Planning Board Minutes to the Meeting Mebane Municipal Building January 13, 2020 6:30 p.m.

RZ 20-04 Conditional Rezoning -Tupelo Junction (formerly "The Landing at Lake Michael)

Technical Memorandum Date: March 5, 2020 To: Montrena Hadley, Planning Officer From: Franz K. Holt, P.E. Subject: Tupelo Junction– City Engineer review

PROPOSED TRAFFIC OPERATIONS

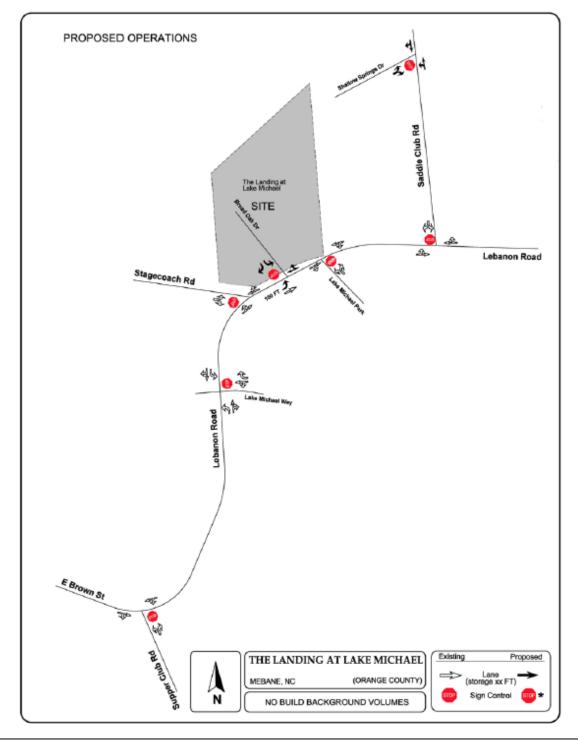
- 7. Figure 10: Proposed Traffic Operations The Stop signs at the site driveways should be indicated as proposed by using an asterisk as noted in the legend.

TRC NOTES:

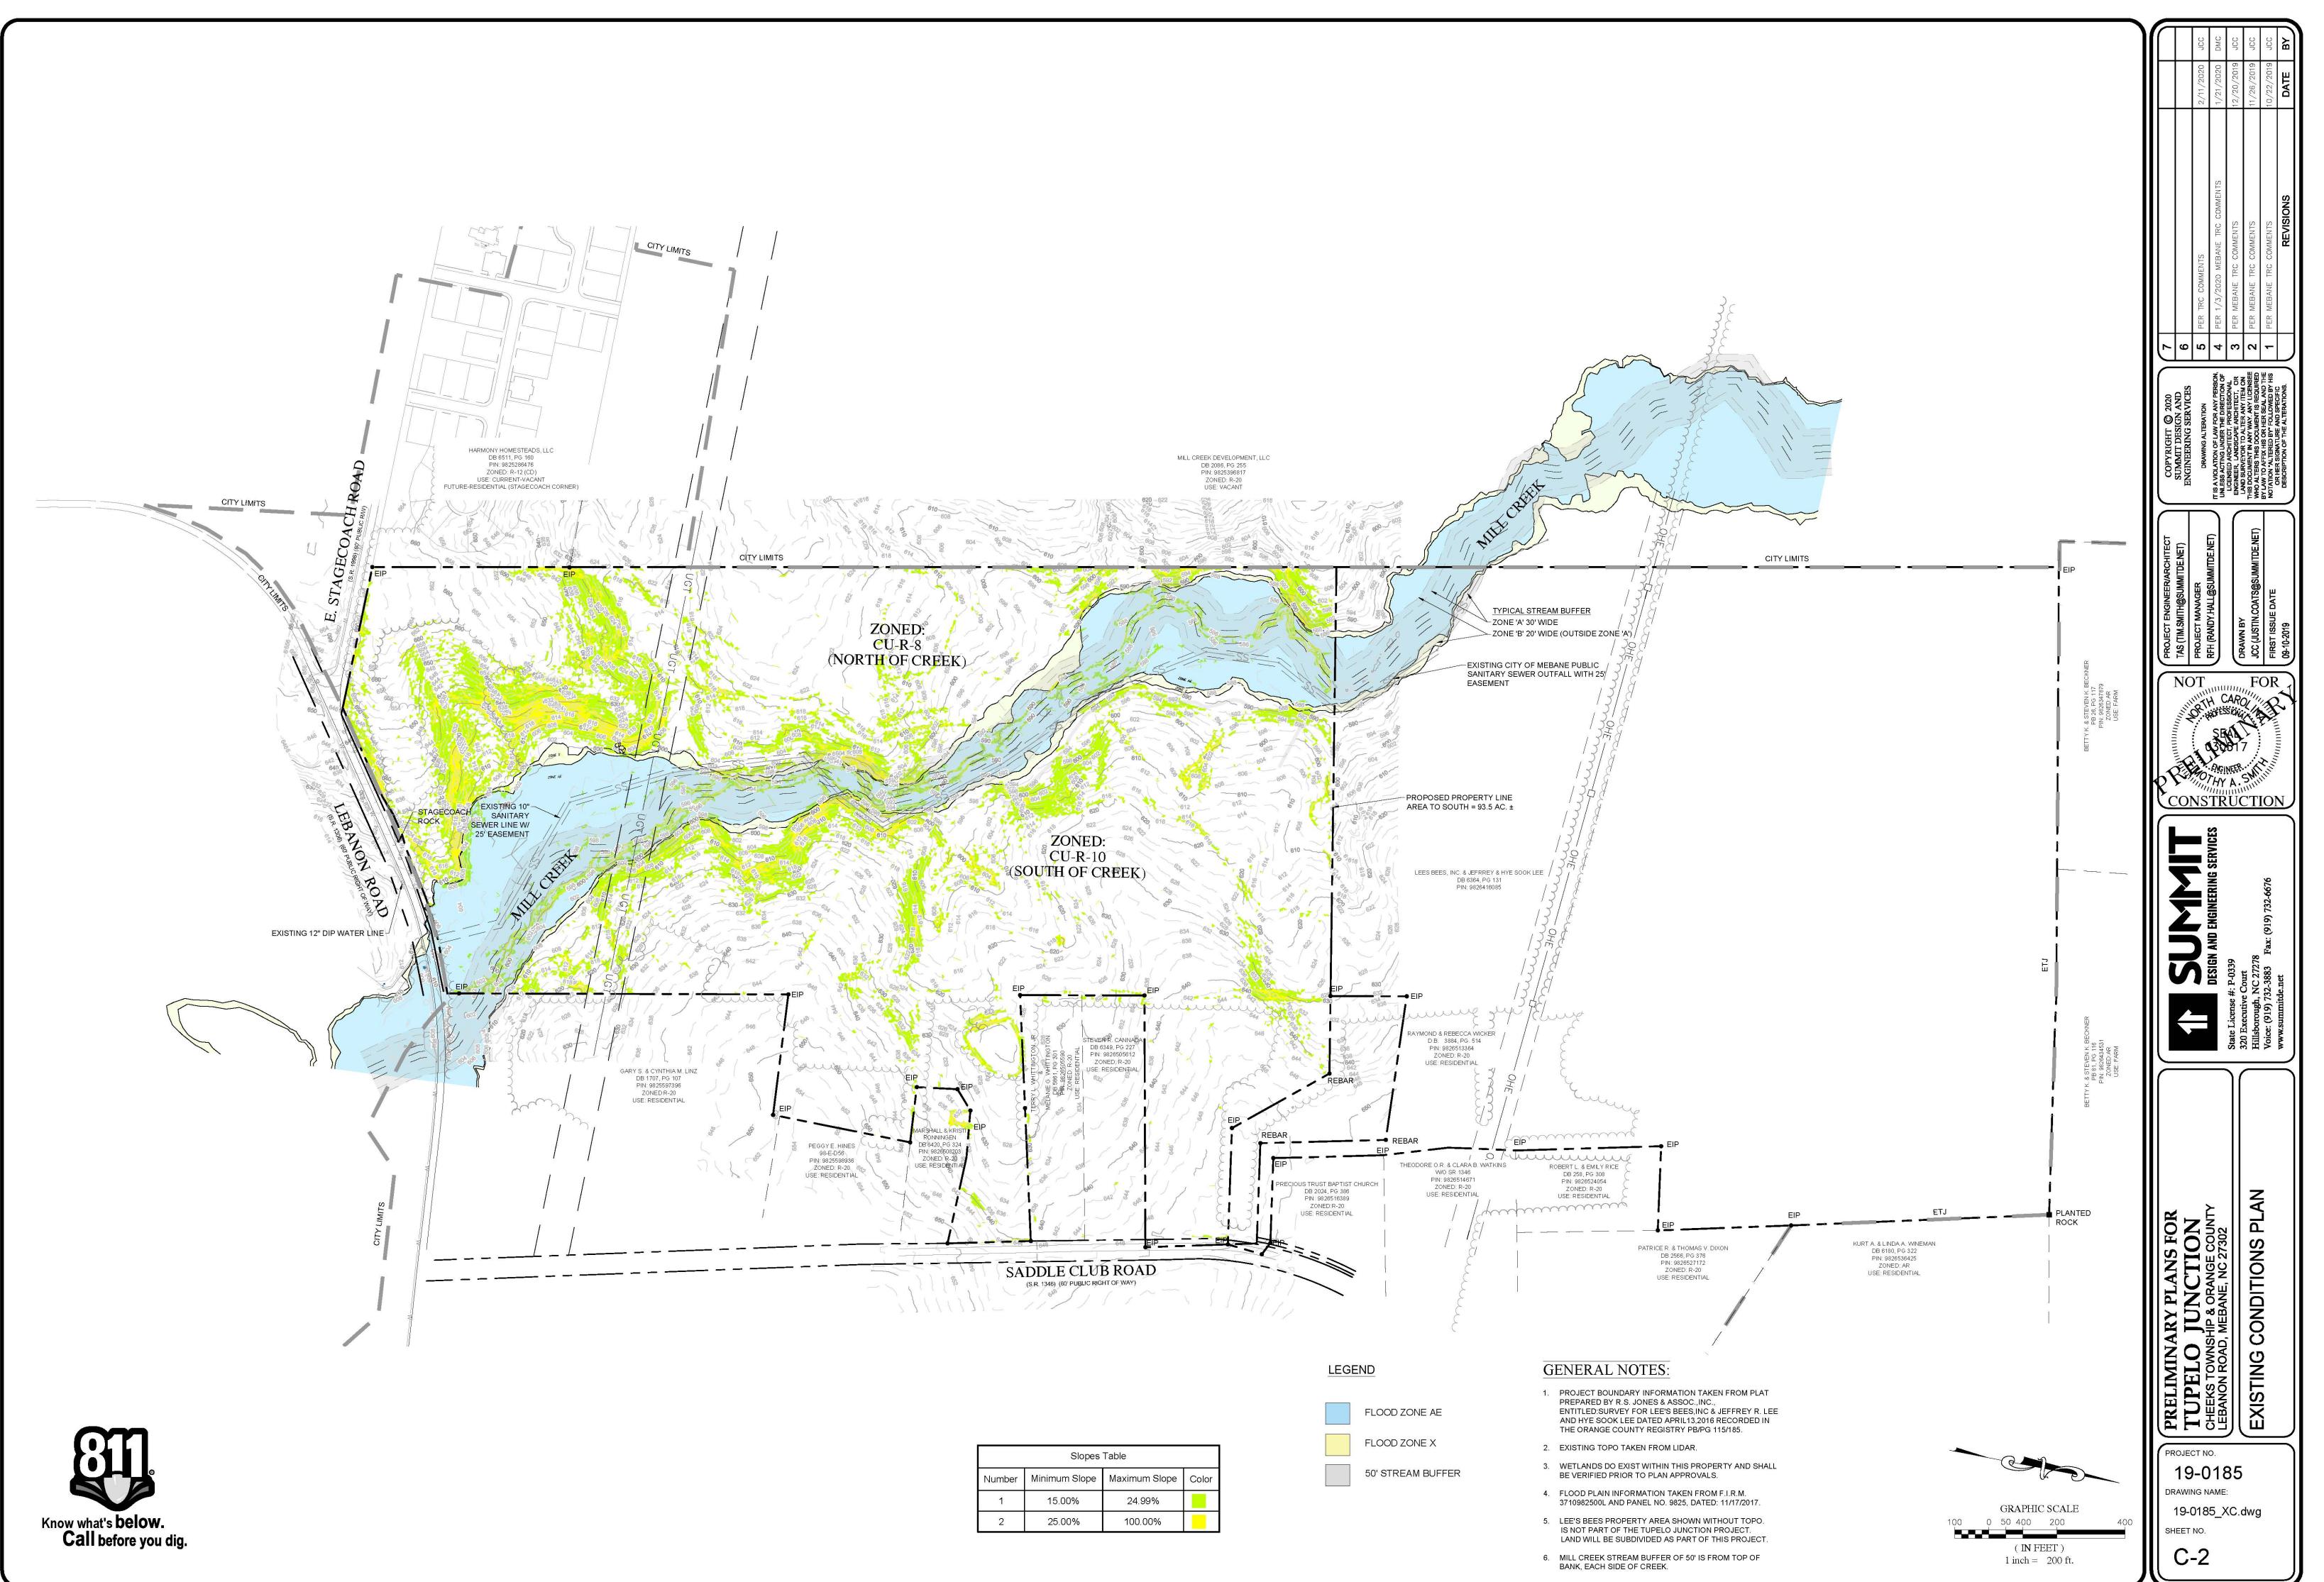
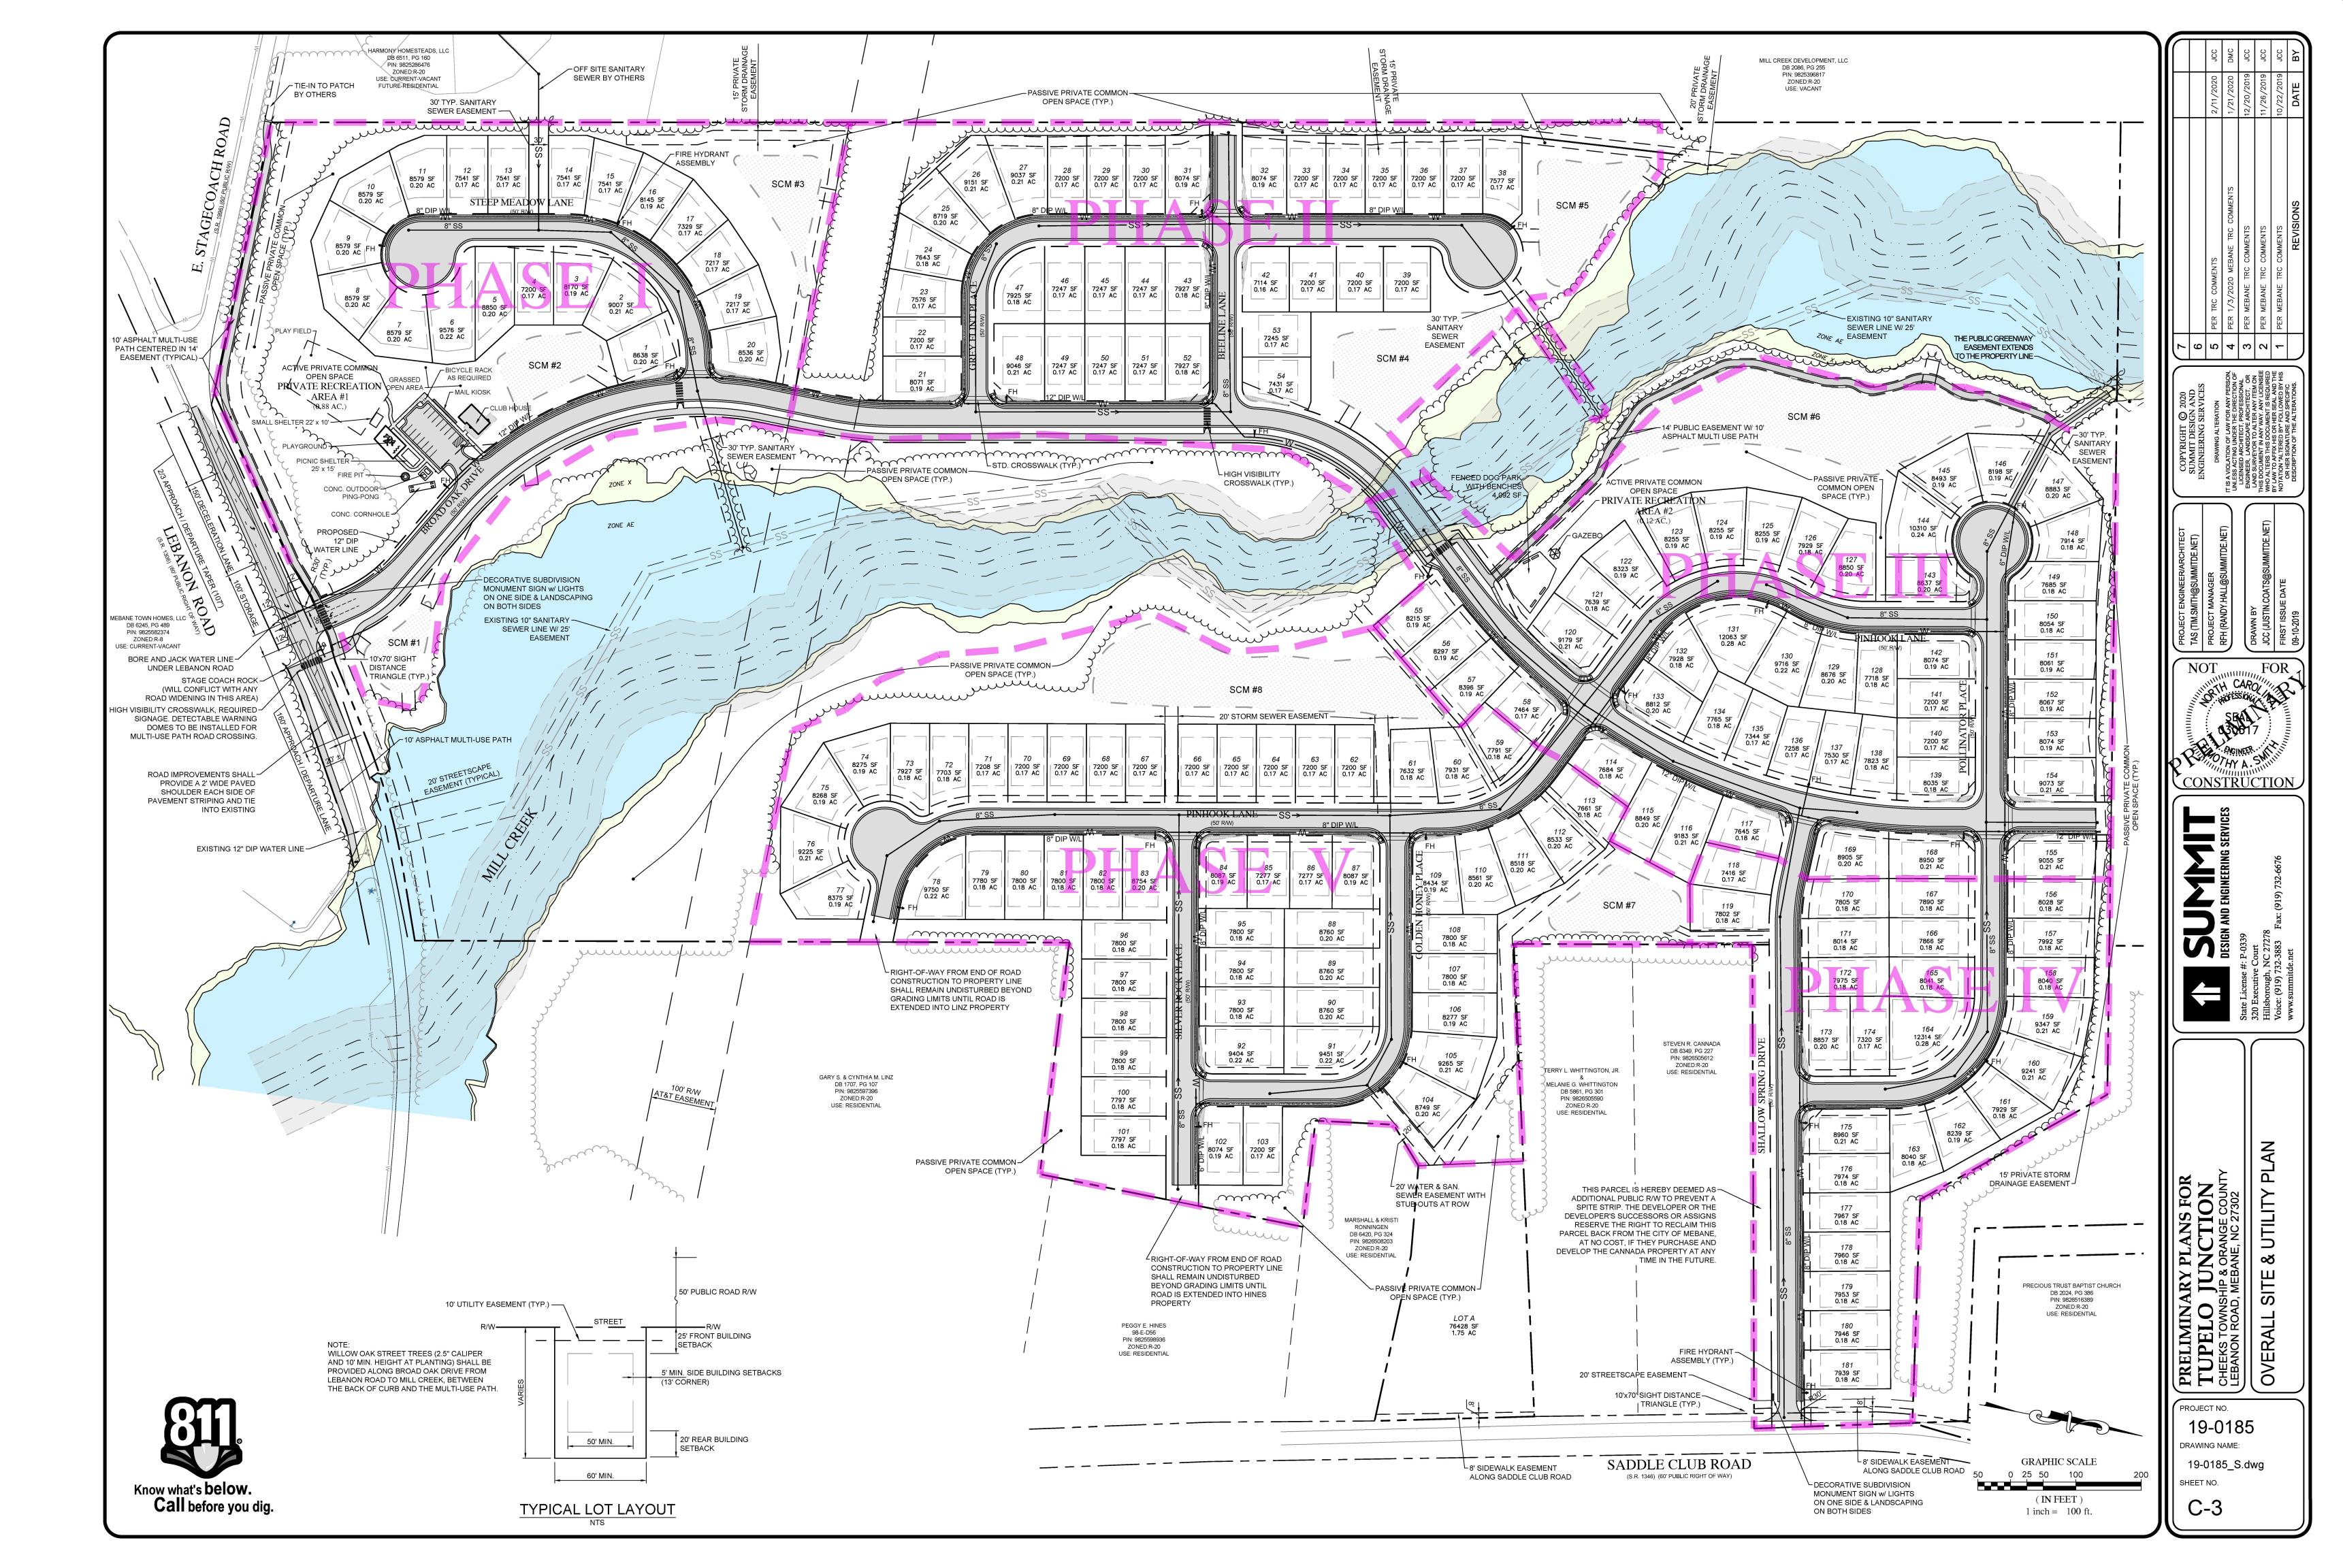
- 1. THE NEW CULVERT FOR ON-SITE CREEK CROSSING SHALL PASS THE 100 YEAR STORM WITHOUT TOPPING THE ROADWAY. SIZING AND MATERIAL TO BE DETERMINED WITH THE CONSTRUCTION DRAWINGS.

- 2. ALL NEW ROADS ARE CONSIDERED LOCAL RESIDENTIAL AS DETERMINED BY THE PROJECT TRAFFIC ENGINEER AND WILL BE BUILT TO CITY
- STANDARDS AND MAINTAINED BY THE CITY OF MEBANE AFTER FINAL ACCEPTANCE.

- 7. THE AMENITY AREA, PARKING LOT, AND STORMWATER CONTROL MEASURES SHALL BE SCREENED WITH LANDSCAPING AND/OR BERMS. ALSO, THE RECREATION AREA SHALL BE SCREENED FROM THE RESIDENTIAL LOTS WITHIN THE SITE. ALL SCREENING SHALL BE IN ACCORDANCE WITH THE MEBANE UDO AND WILL BE INCLUDED WITH THE LANDSCAPING PLANS PROVIDED WITH THE CONSTRUCTION DRAWINGS FOR APPROVAL BY THE CITY OF MEBANE. ANY STORMWATER CONTROL MEASURES THAT POND OR HOLD 2 FEET OF WATER SHALL BE FENCED FOR SAFETY.

- 8. A CULTURAL RESOURCES ASSESSMENT HAS BEEN PROVIDED BY THE THE NC STATE HISTORIC PRESERVATION OFFICE. NO HISTORIC RESOURCES WERE FOUND WITHIN THE PROJECT AREA. WE HAVE REQUESTED THEM TO TAKE ANOTHER LOOK INTO THE STAGECOACH ROCK AND ARE AWAITING THEIR RESPONSE. THE "STAGECOACH ROCK" HAS BEEN DEEMED AS A POSSIBLE SAFETY HAZARD TO VEHICULAR TRAFFIC BY NCDOT. RELOCATION OF THE ROCK SHALL BE COORDINATED WITH AND APPROVED BY N.C.D.O.T. THIS NEW LOCATION SHALL BE EITHER ON SITE OR AT LAKE MICHAEL PARK.

- 19. THE CURRENT PLANS INDICATE PRELIMINARY DRAINAGE EASEMENTS OVER PIPES AND ENGINEERED SWALES. AS PHASED CONSTRUCTION DRAWINGS ARE FINALIZED ALL DRAINAGE WAYS (5 CFS OR MORE) SHALL HAVE A DEDICATED DRAINAGE EASEMENT PER THE CITY OF MEBANE STORM SEWER DESIGN MANUAL WHETHER PIPED OR UN-PIPED.
